<b>T.I. No.:</b> 2020 - 22 <b>Updated:</b> -	<b>Topic:</b> SC Club Software Version 1.9.4
---	--

<b>Date:</b> 03.12.2020	<b>Priority</b>	<b>Need for action</b>
<b>Affected machines:</b> SC Club	High	As soon as possible
<b>From serial number:</b> -	X Medium	X On next visit to the machine
<b>As of date:</b> immediately	Low	FYI

### Dry pressing

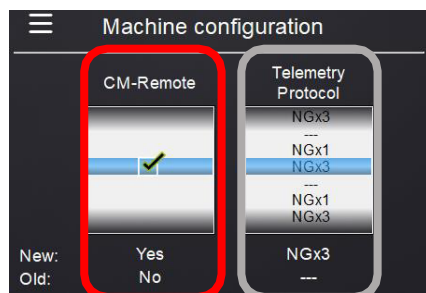
With the software version 1.8.3 a modified dry pressing process was accidentally introduced. This leads to a slightly increased amount of remaining coffee being fed back through the silicone fabric hoses into the drip tray during dry pressing after brewing. On machines with a large number of brewing cycles and long operating times, the oils and fats contained in the coffee can diffuse through the silicone fabric hoses and cause the hose surface to turn coffee brown.

Tests have shown that this diffusion has merely a visual effect on the silicone fabric hoses from the brewer back to the release valve. No functional/operational malfunctions are to be expected.

### Schaerer SmartRemote

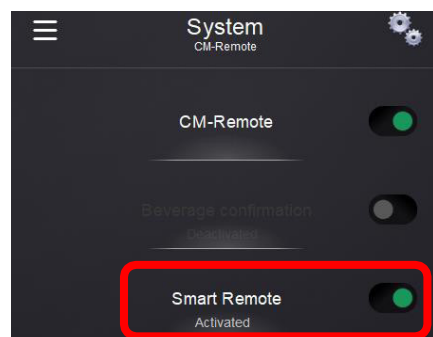
With the new feature "WMF SmartRemote" there is the possibility to release beverages via smartphone - without touching the touch screen on the coffee machine.

Precondition is that a telemetry module with NGx3 protocol is installed and registered in the CoffeeLink portal of Schaerer.

The general software activation is done under System > **Machine configuration** > **CM-Remote**

Important: Check whether the installed NGx3 telemetry module is activated. (marked grey)

Under **System** > **CM-Remote Smart Remote** can then be activated or deactivated - even by the operator himself.

## Coloured background for beverage buttons

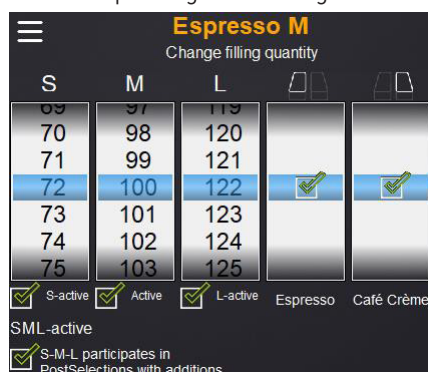
With the new software version it is now possible to adjust the colour background of the beverage buttons.

Before the background colour of the beverage buttons can be changed, the function must be activated under:

**System > Display and illumination > Beverage background.**

Only after this, it is possible to set the beverage background colour in the beverage menu under  .
